CITY OF CODY PLANNING, ZONING AND ADJUSTMENT BOARD STAFF REPORT			
MEETING DATE:	JUNE 23, 2020	***TYPE OF ACTION NEEDED***	
AGENDA ITEM:		P&Z BOARD APPROVAL:	
SUBJECT:	FINAL PLAT AND CONSTRUCTION PLANS FOR THE LANDING SUBDIVISION— A 55-LOT SUBDIVISION. SUB 2020-02	RECOMMENDATION TO COUNCIL:	X
PREPARED BY:	TODD STOWELL, CITY PLANNER	DISCUSSION ONLY:

Kip B. Thiel Construction Inc. has submitted the construction plans, final plat, and associated documents for The Landing Subdivision. The final plat includes 55 lots on the 17.57-acre property located at the north end of 37th Street, about 235 feet north of the intersection with Cherokee Road. The property is currently undeveloped and all proposed lots are intended for single-family residences. The property is zoned Residential R-2 (effective upon recording of final plat).

PARK COUNTY, CODY, WYOMING
THE LANDING MAJOR SUBDIVISION
PHASING PLAN

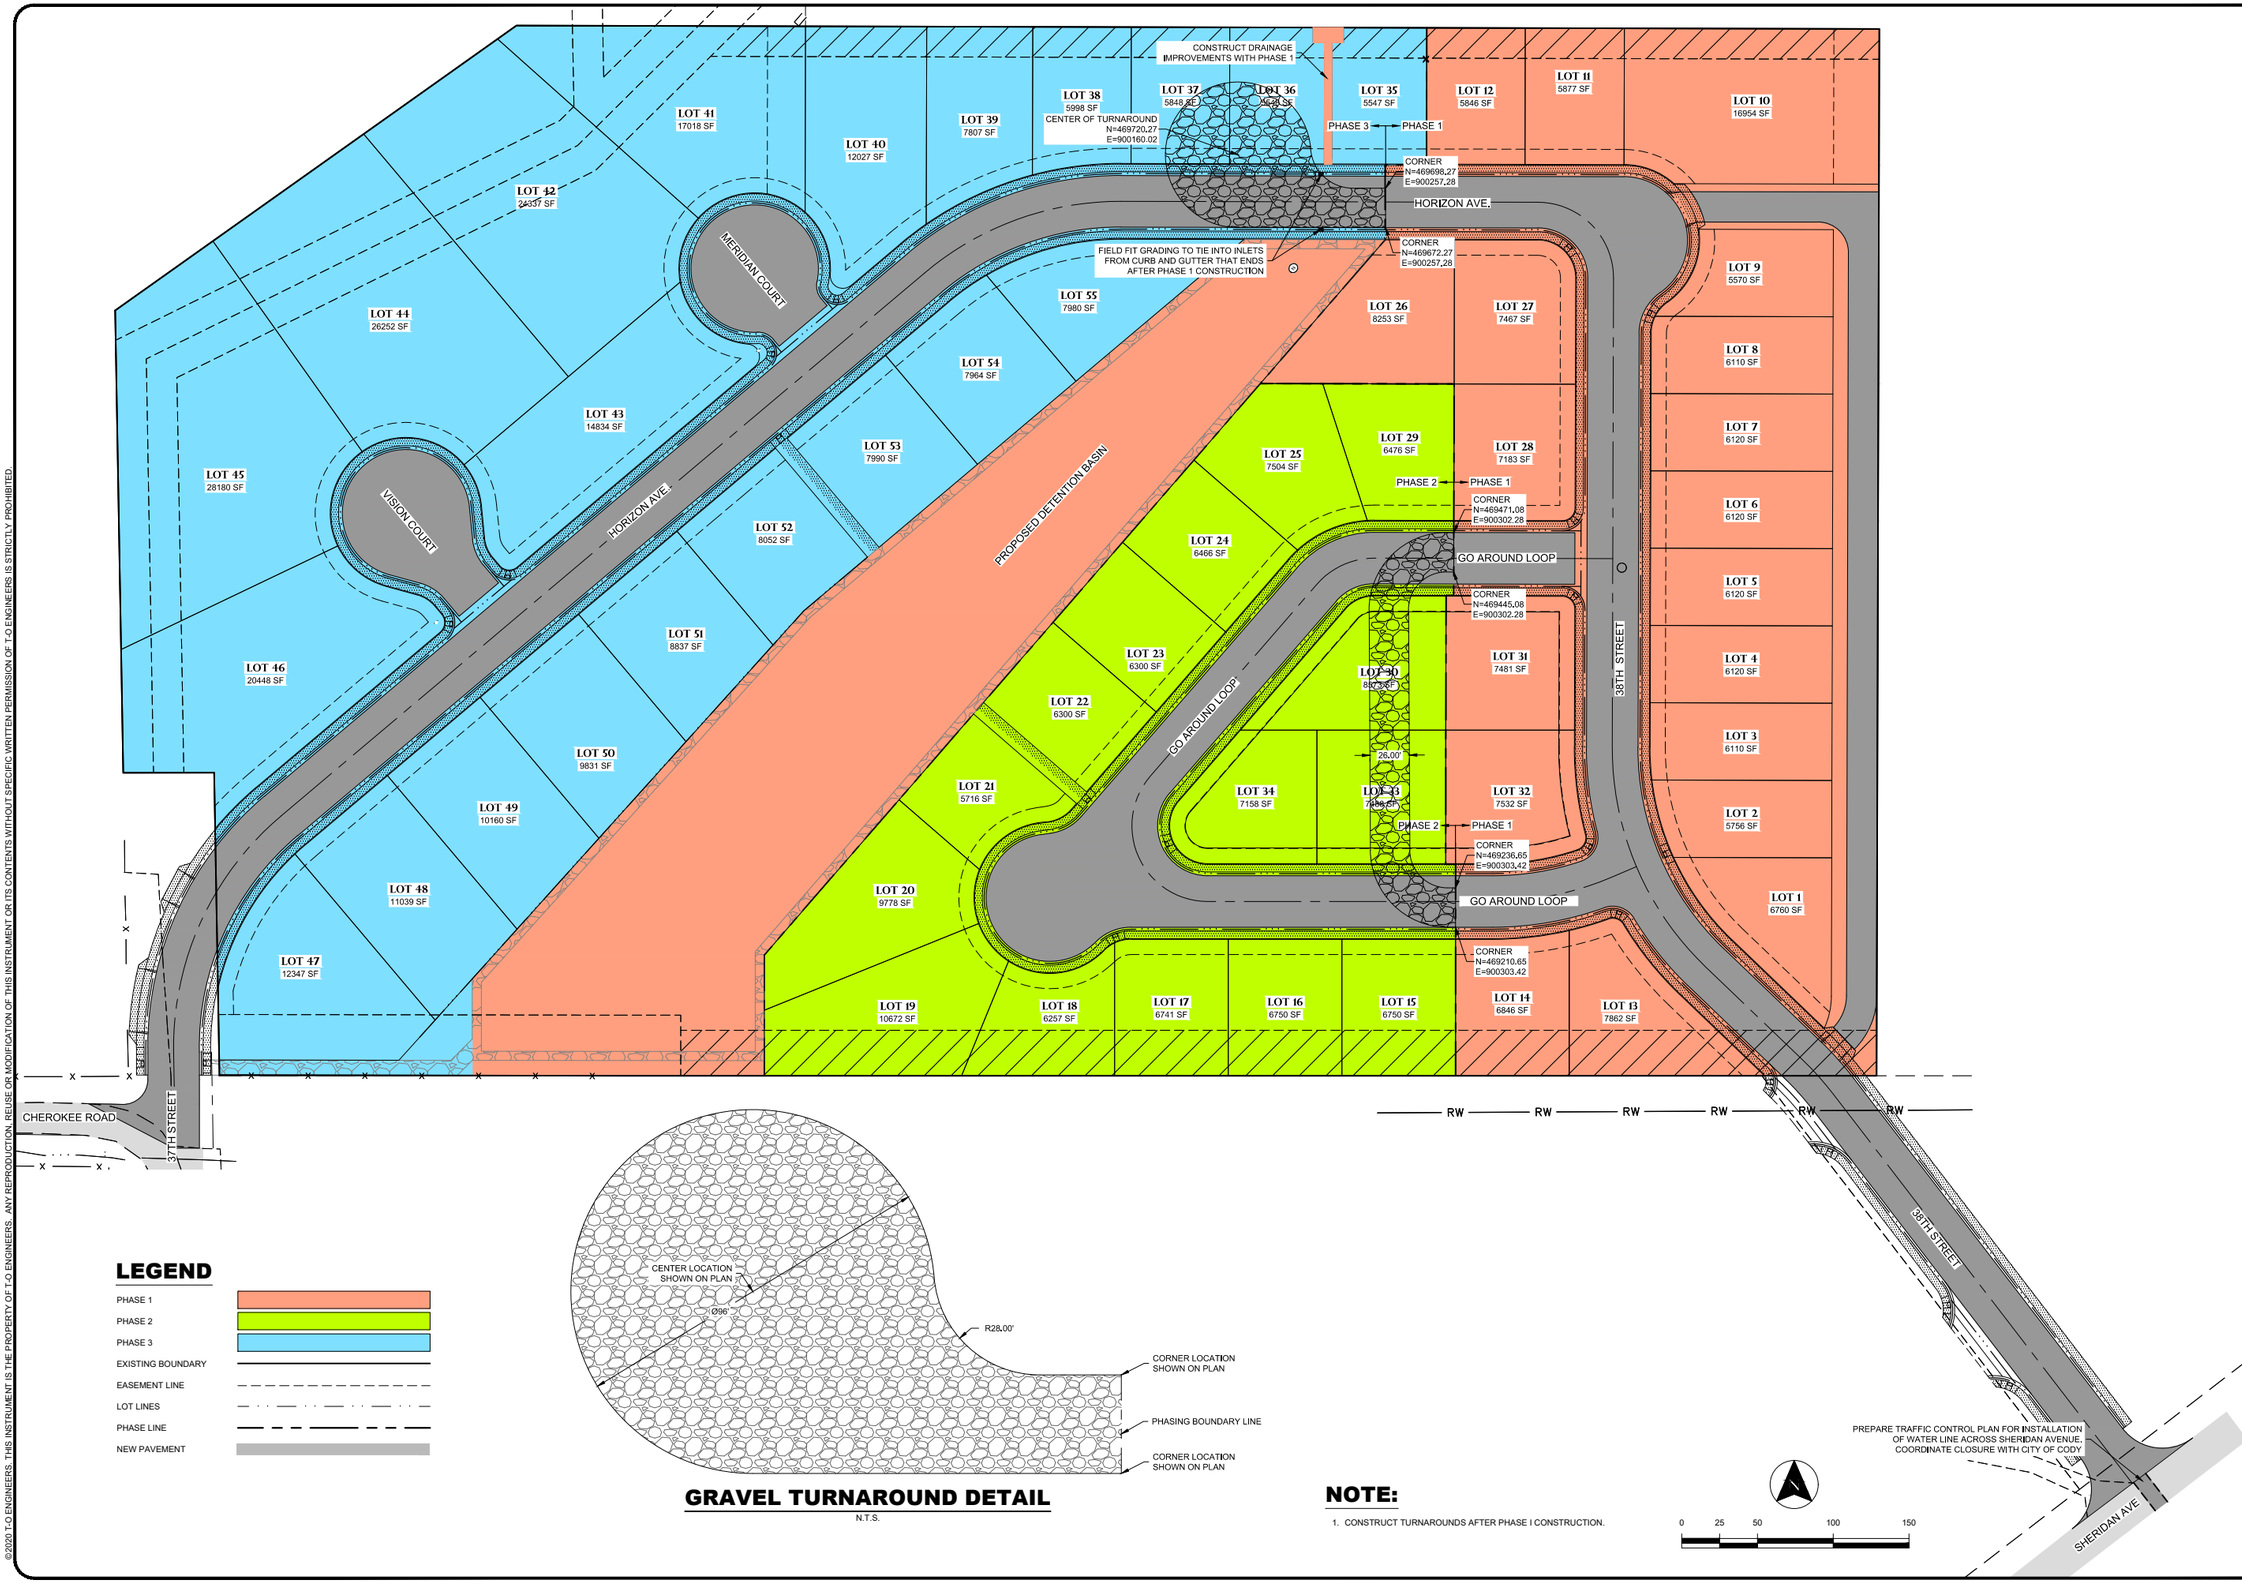
8. The improvements for Phase 1 must be modified to extend the curb and gutter and subgrade to BVC 20+25, so that the associated storm water control measures are in place with Phase 1. (Sheet 4)

HORIZON AVE ROADWAY PLAN & PROFILE - SHEET 2

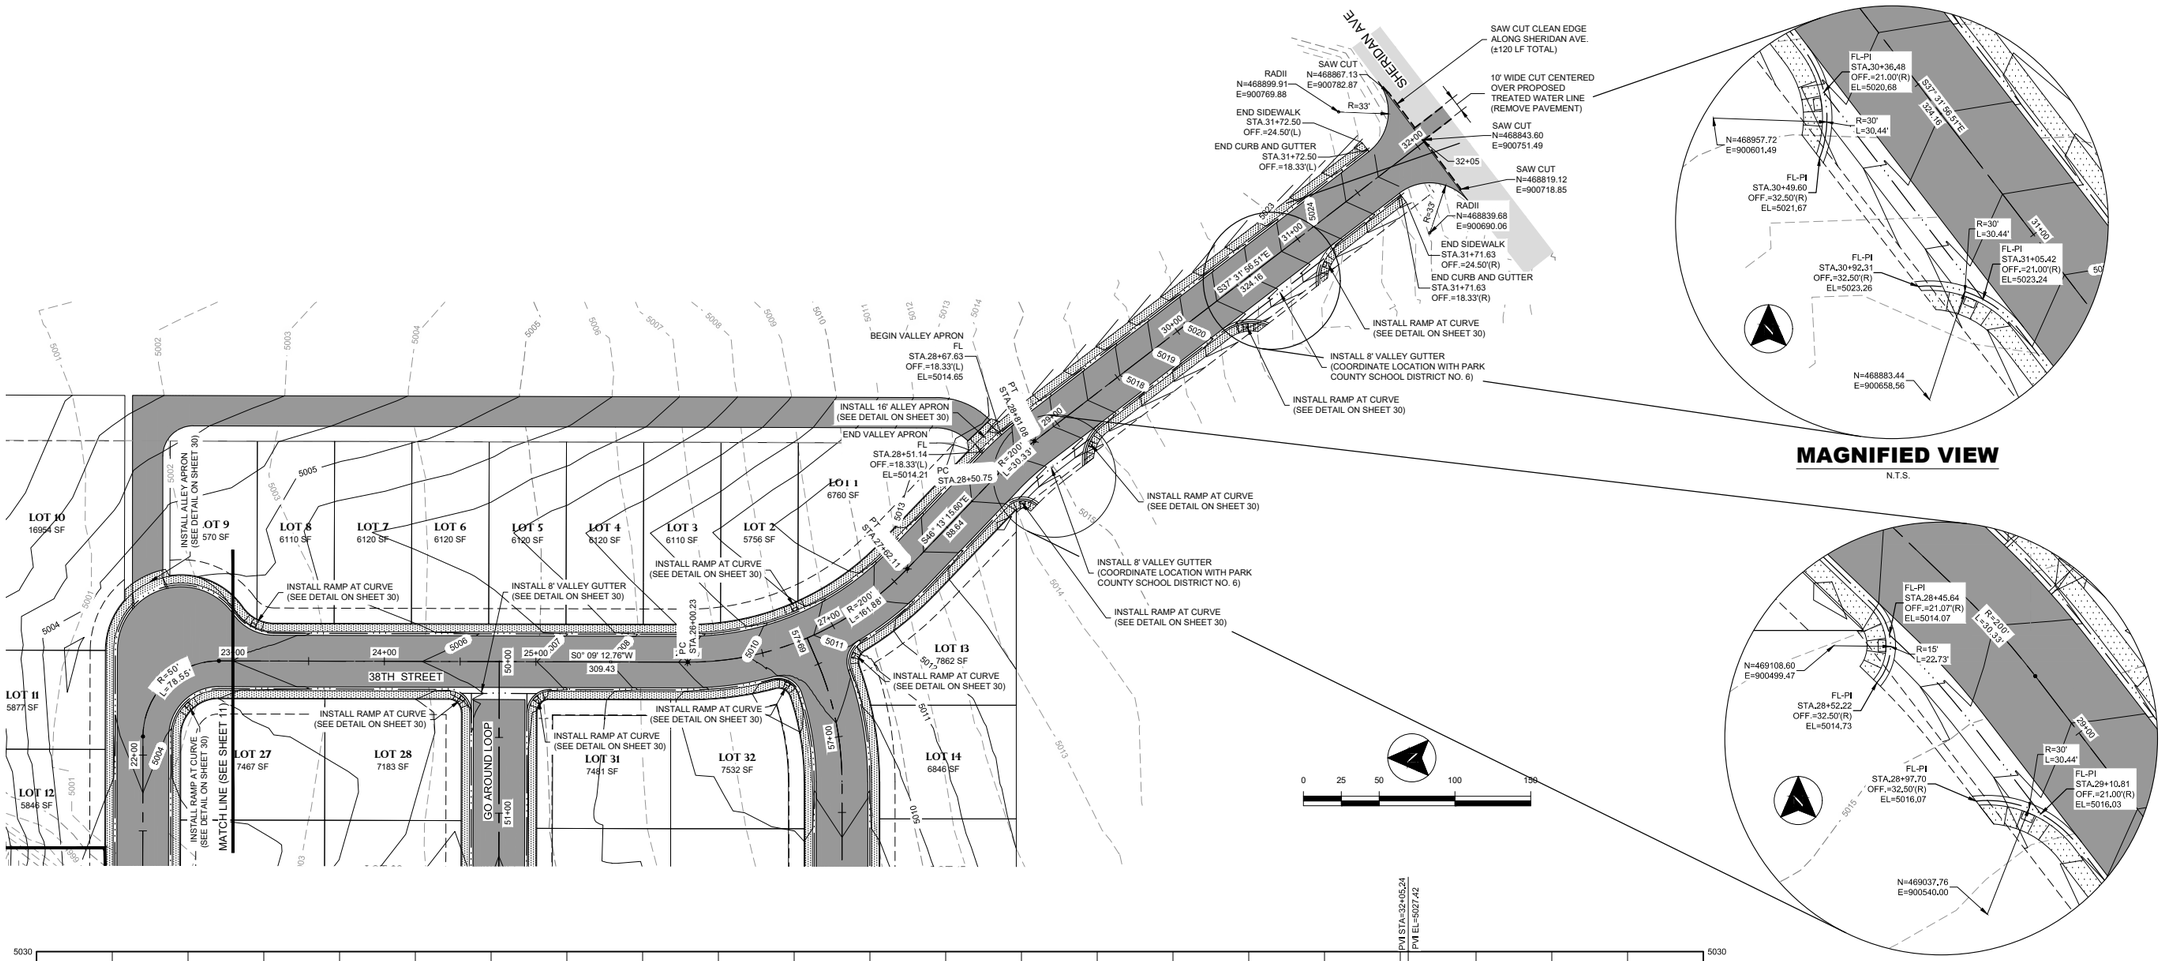
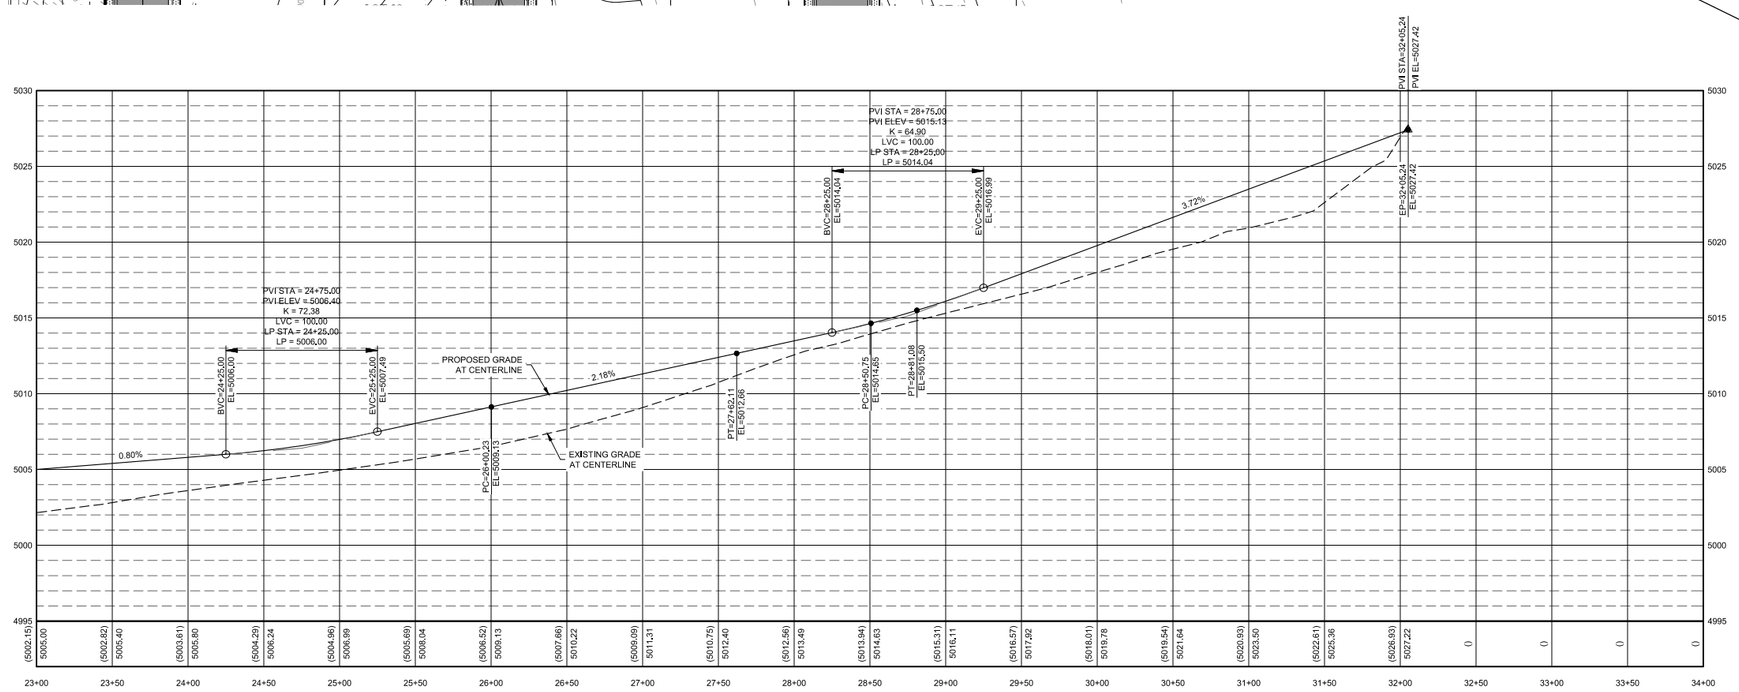
11. Widen the south alley approach to 20 feet to match the alley width (Sheet 12).
12. Modify the sewer services as needed, so that they do not run directly into the manhole (those in cul-de-sacs and a few others).

GO AROUND LOOP PLAN & PROFILE

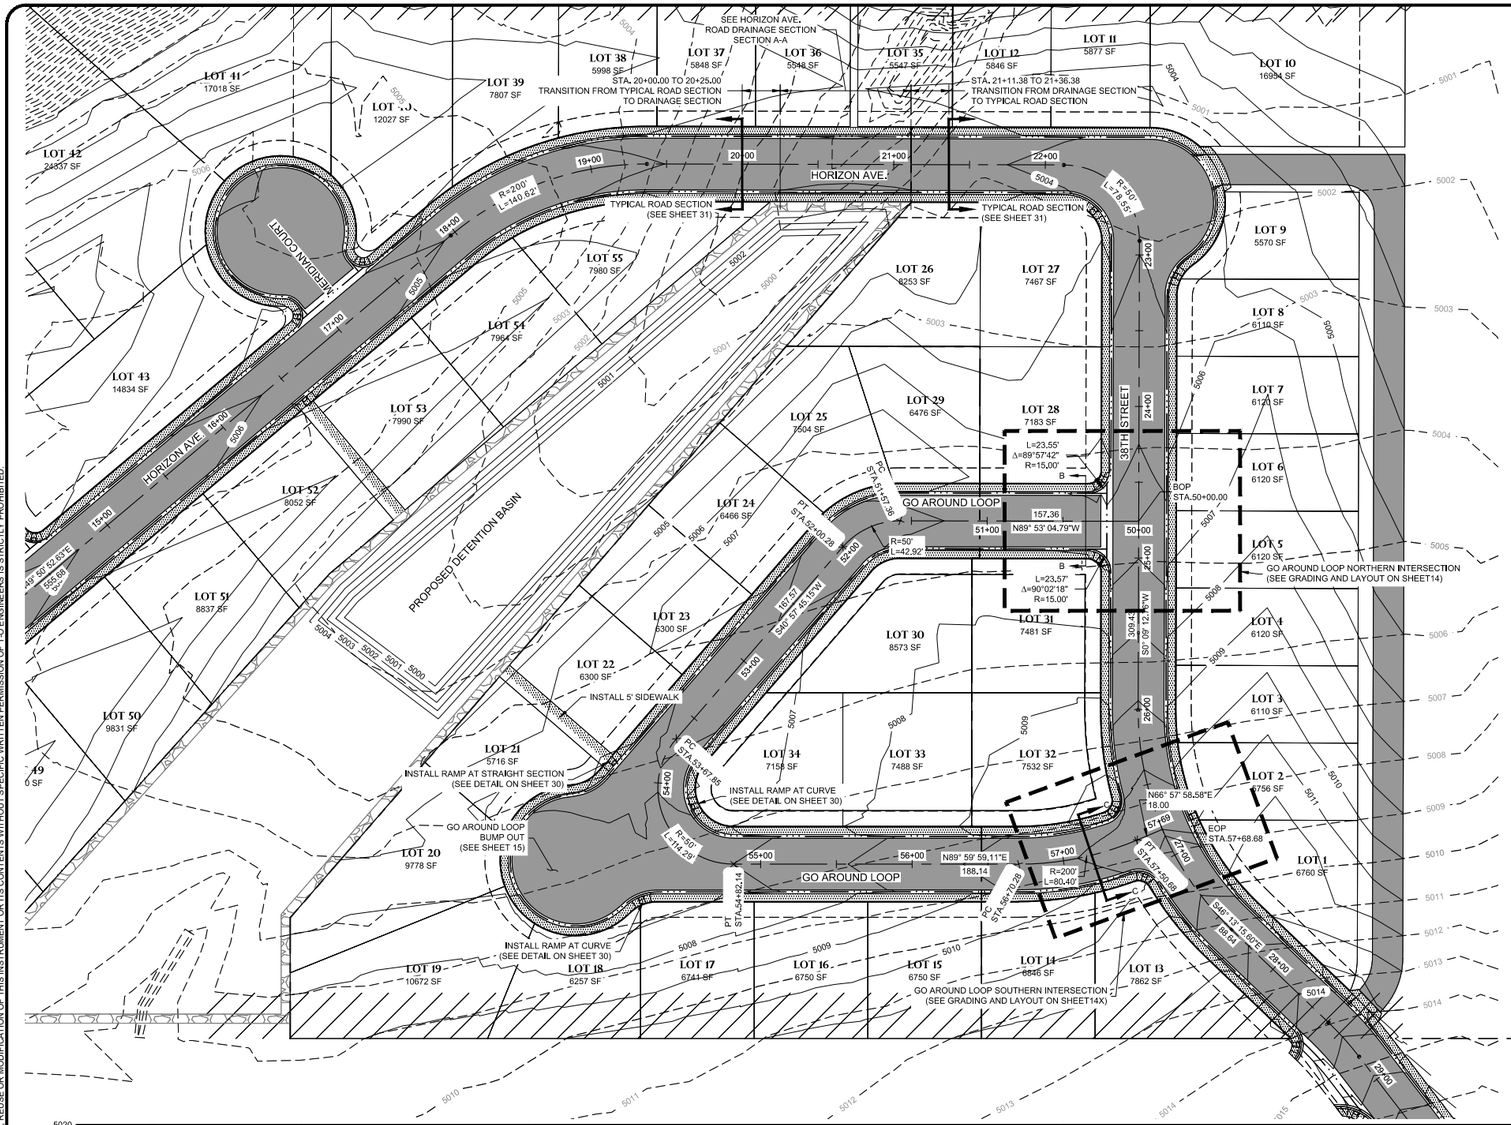
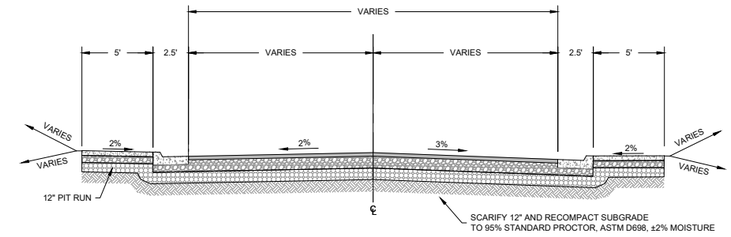
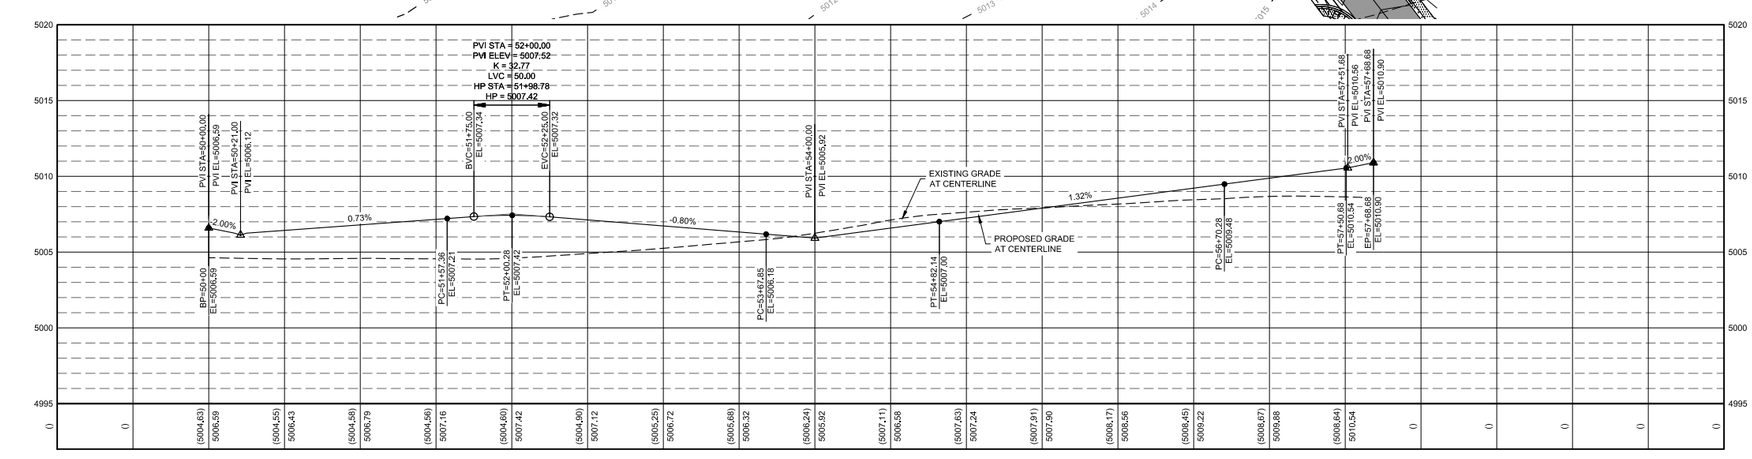
13. Add the vertical curve information on the low point of Go Around Loop (Sheet 13).
14. On the first detail on Sheet 14, use standard curb on both sides.
